REQUEST FOR EXCEPTIONS TO PUBLIC ROAD STANDARDS –24 LOTS AND A REMAINDER LOT LOCATED IN THE UNINCORPORATED PORTION OF SAN DIEGO COUNTY WITHIN THE LAKESIDE COMMUNITY PLAN AREA, PDS2014-TM-5582

REQUEST FOR EXCEPTIONS TO PUBLIC ROAD STANDARDS – 24 LOTS AND A REMAINDER LOT LOCATED IN THE LAKESIDE COMMUNITY PLAN AREA, PDS2014-TM-5582

REQUEST FOR AN EXCEPTION TO A ROAD STANDARD –TM 5582

Ref.: Lemon Crest , PDS2014-TM-5582, Design Speed Exception Request

EXHIBIT-A
(PROPOSED 25 MPH)

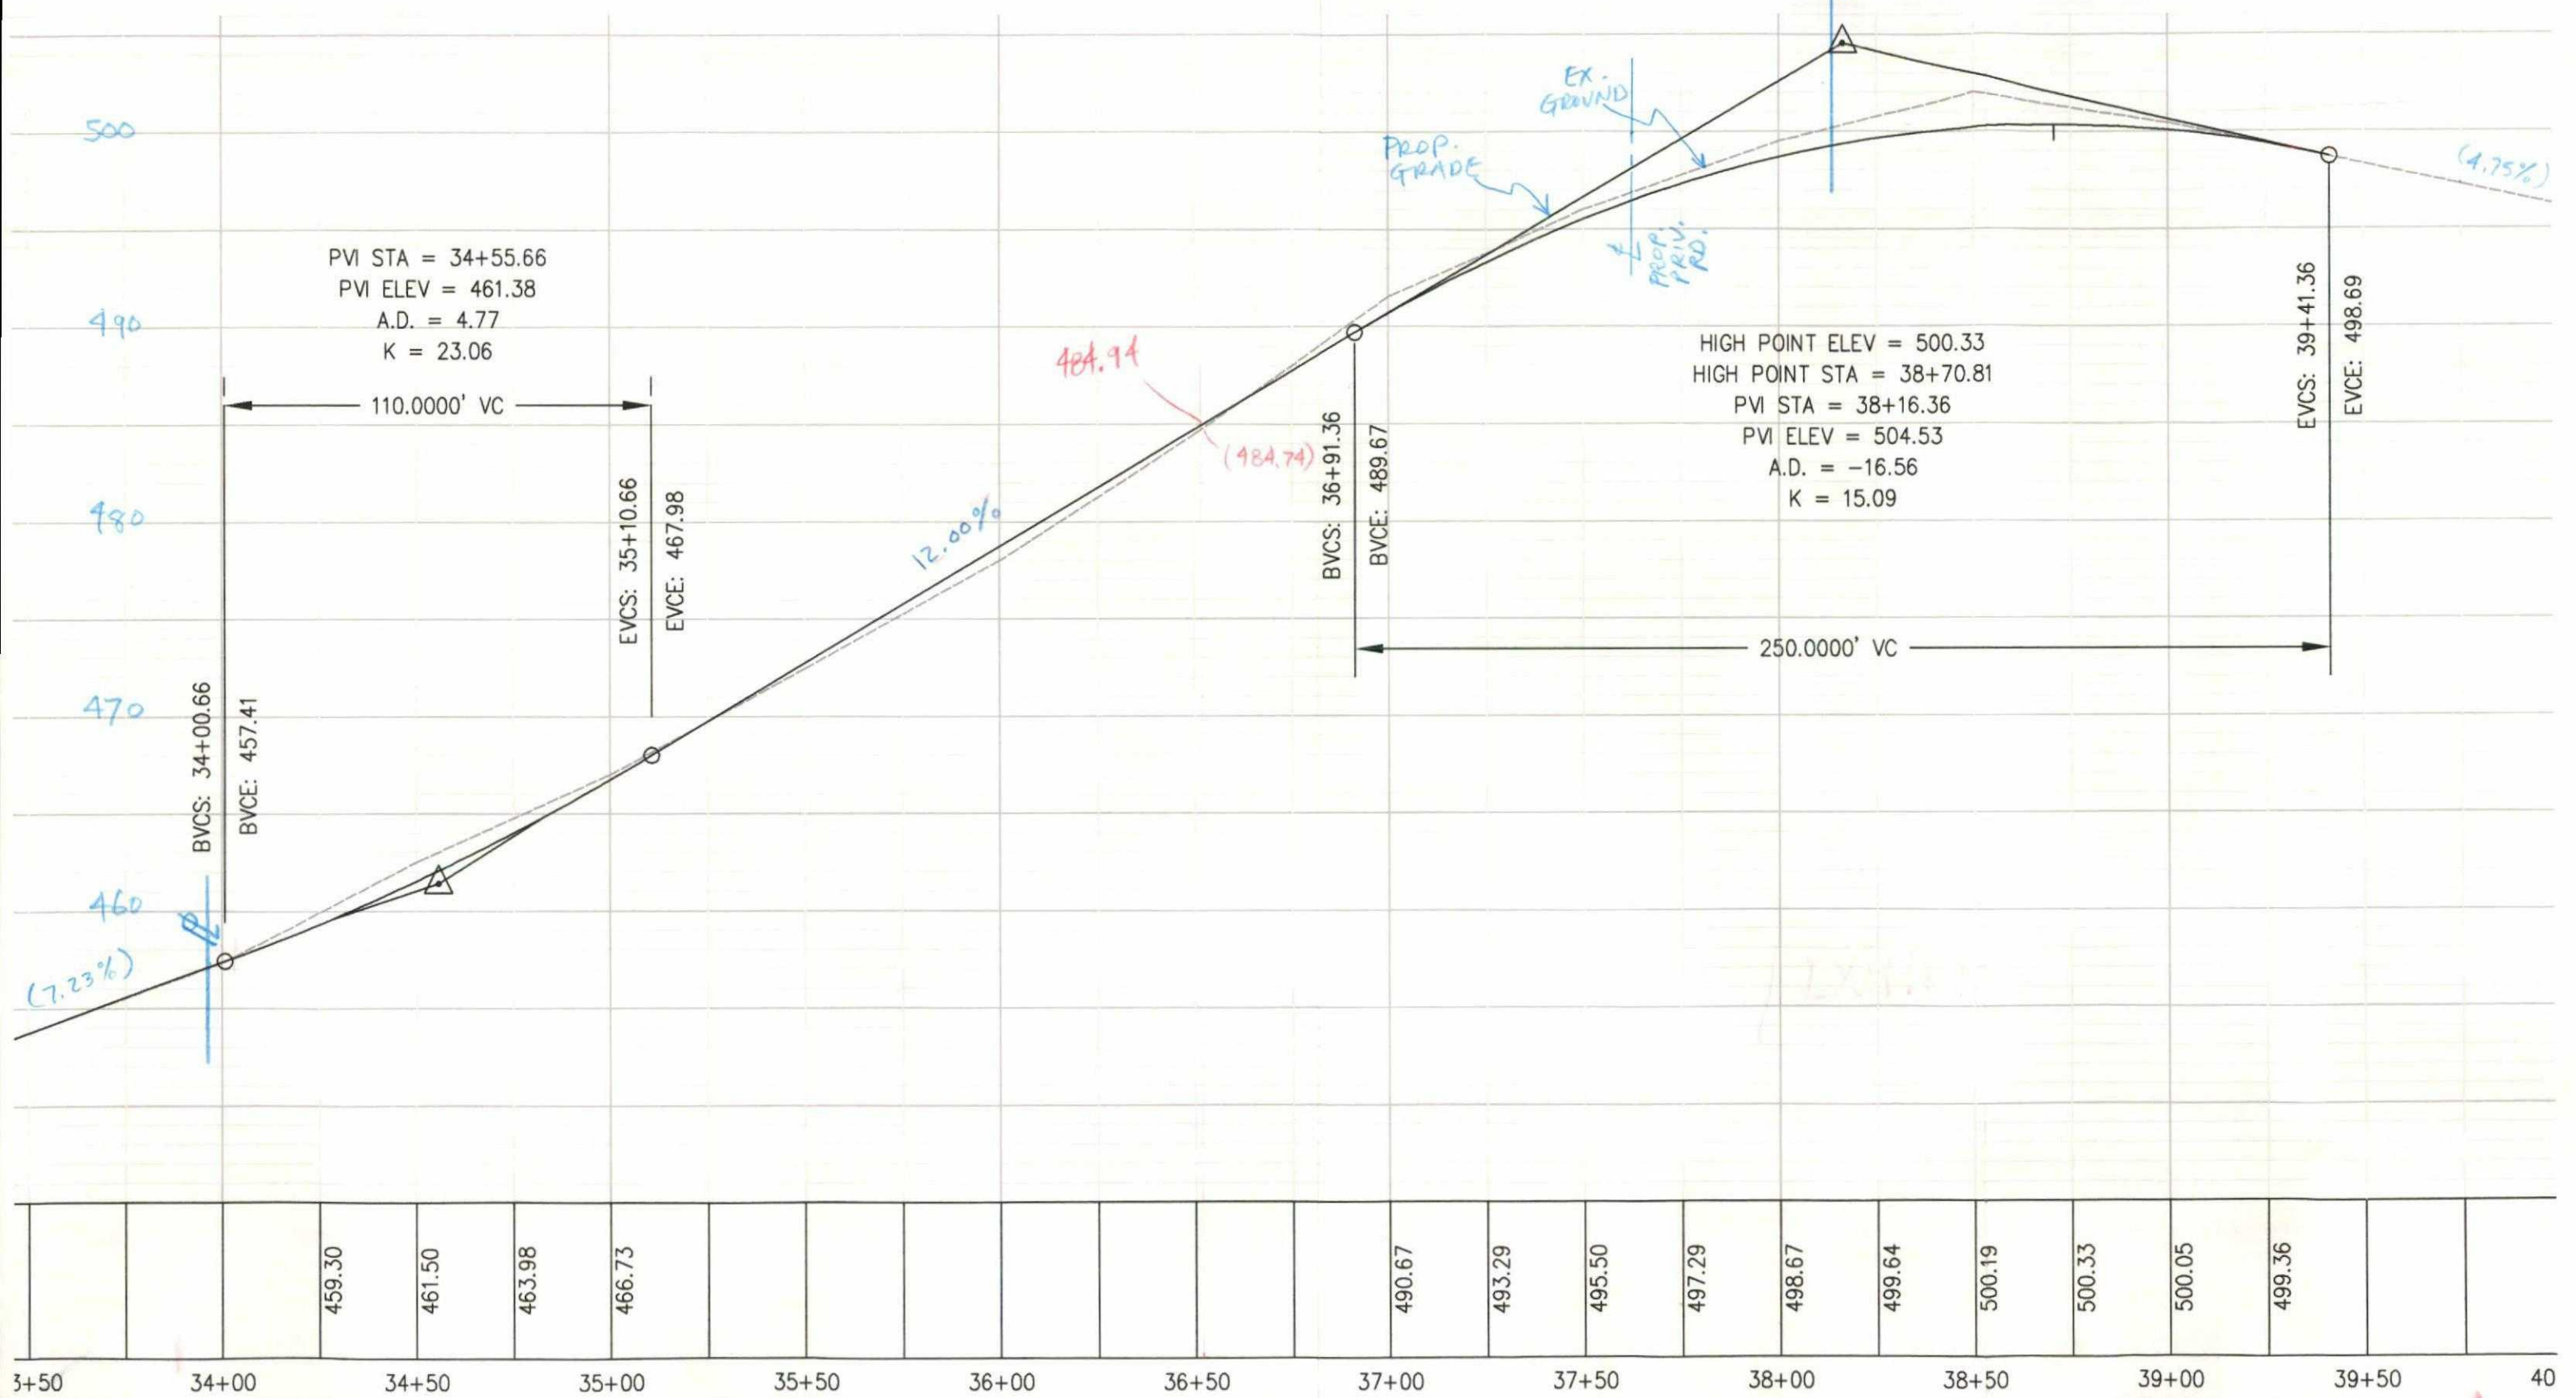
Requested Exception/ Modification (attach engineering sketches showing existing layout, details and notes): Reduce the vertical design speed suggested in table 2B of the County of San Diego – Public Road Standards for a Residential Collector, 30 mph, to approximately 25 mph to allow for a 250 foot crest vertical curve for Lemon Crest Drive as it goes Easterly along the project frontage before descending towards Julian Avenue (passing by Lemon Crest Elementary School). See exhibits A and B. NOTE: Based on stopping sight distance per CALTRANS Highway Design Manual, Fig. 201.4, Stopping Sight Distance on Crest Vertical Curves.

EXHIBIT-C
(30 MPH PROFILE)

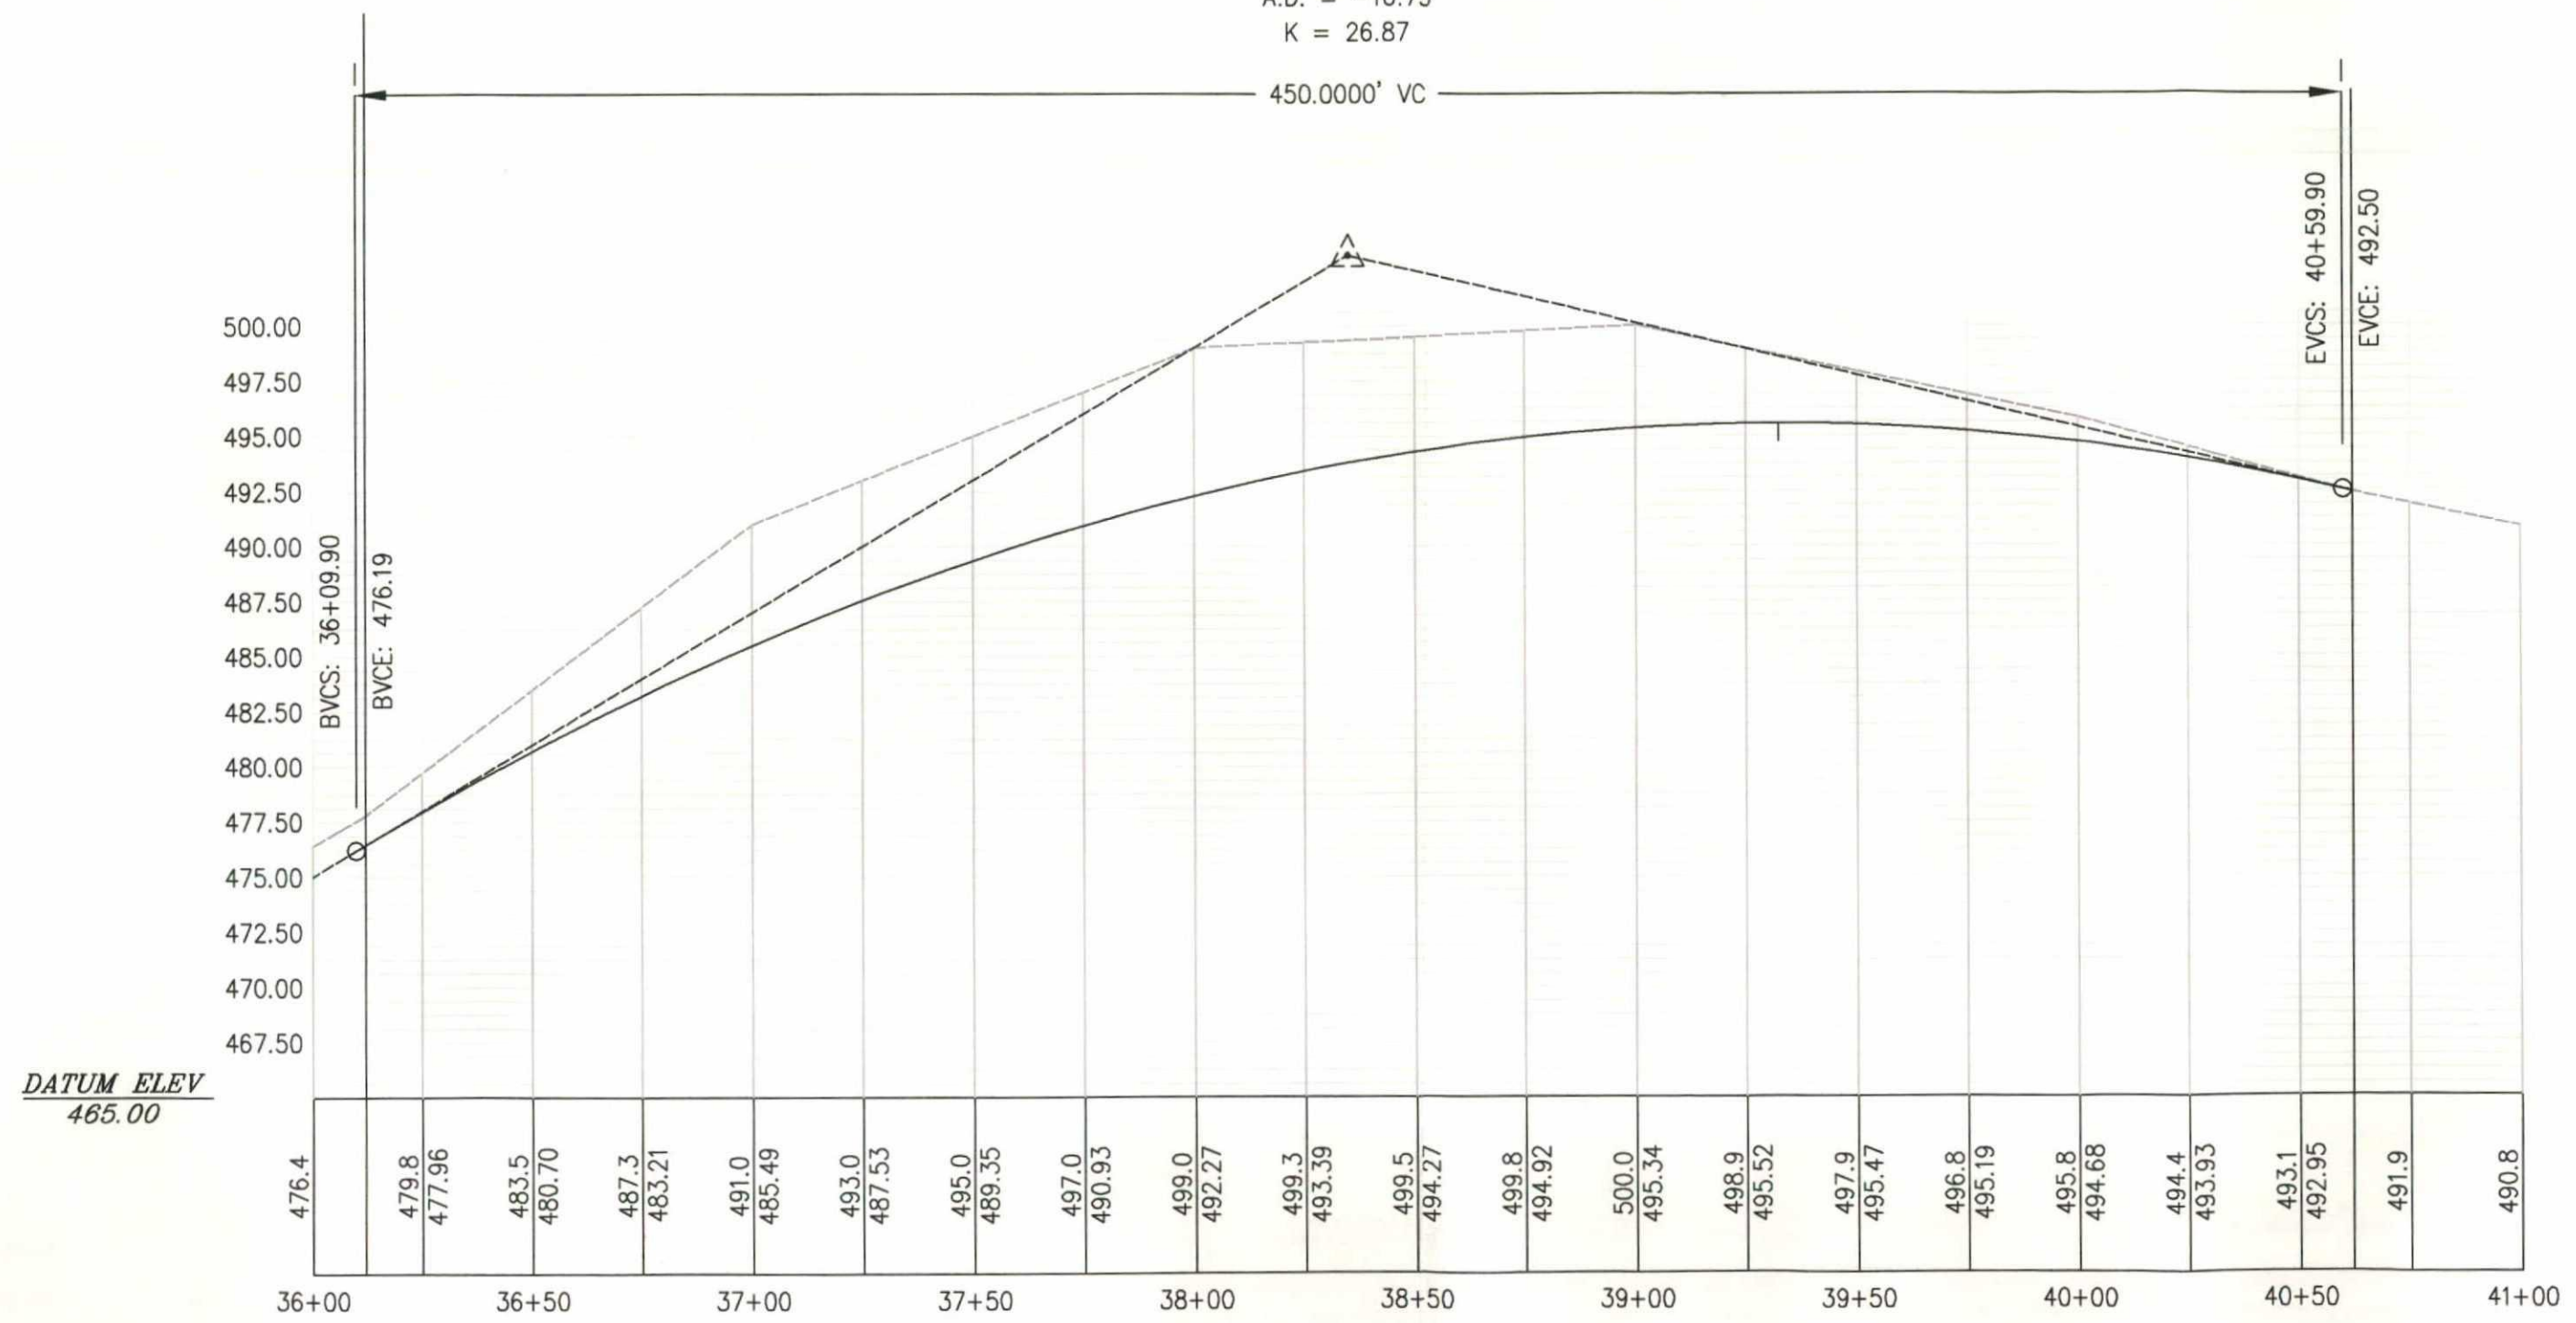
We considered a 27 mph design speed but similar to a 30 mph design speed it would necessitate lowering of the crest by approximately 4 feet and tapering back to existing. This would cause the removal of about 400 feet of the existing road and cause the need of relocation of existing mains and gas main and service connection. It is important to note that due to the allowance of the existing driveways serving 12378 and

12406 to be connected to the existing edge of paving at nearly 20% grade it would not be possible to grade an ultimate 30 mph roadbed in the current location and reconnect the driveways to meet current standards. In particular at the edge of the right of way at 12378 the elevation would be dropped by about 4 feet and there is not enough ramp length between the garage apron and the right of way to create a 20% or even 25% grade. For this reason and others we proposed moving the road 10 feet into the project and retaining the existing design speed. The centerline shift onsite will be accomplished by transistioning from the existing school district improvements on the east end of the project by reversing horizontal curves. Representations by staff in the minutes of the 8-28-15 meeting are misleading on this subject.
